# UNITED STATES PATENT AND TRADEMARK OFFICE

APPLICATION NO.	FILING DATE	FIRST NAMED INVENTOR	ATTORNEY DOCKET NO.	CONFIRMATION NO.
10/754,445	01/09/2004	Robert A. Ganz	021827-000140US	7989
7590 03/17/2006 CHRISTIANA STATE (REG. NO. 52,045) WILSON SONSINI GOODRICH AND ROSATI 650 PAGE MILL ROAD PALO ALTO, CA 94304			EXAMINER VRETTAKOS, PETER J	
			ART UNIT	PAPER NUMBER
			3739

# Office Action Summary

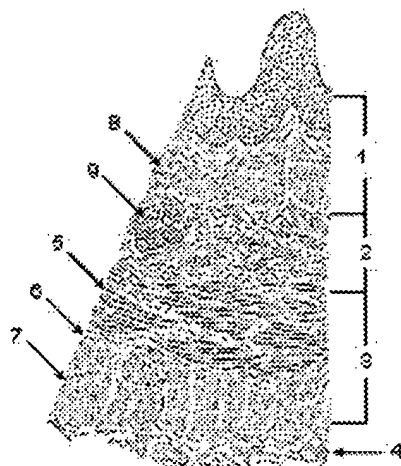
1. Mucosa
2. Submucosa
3. Muscularis
4. Adventitia
5. Striated muscle
6. Striated and smooth
7. Smooth muscle
8. Lamina muscularis mucosae
9. Esophageal glands
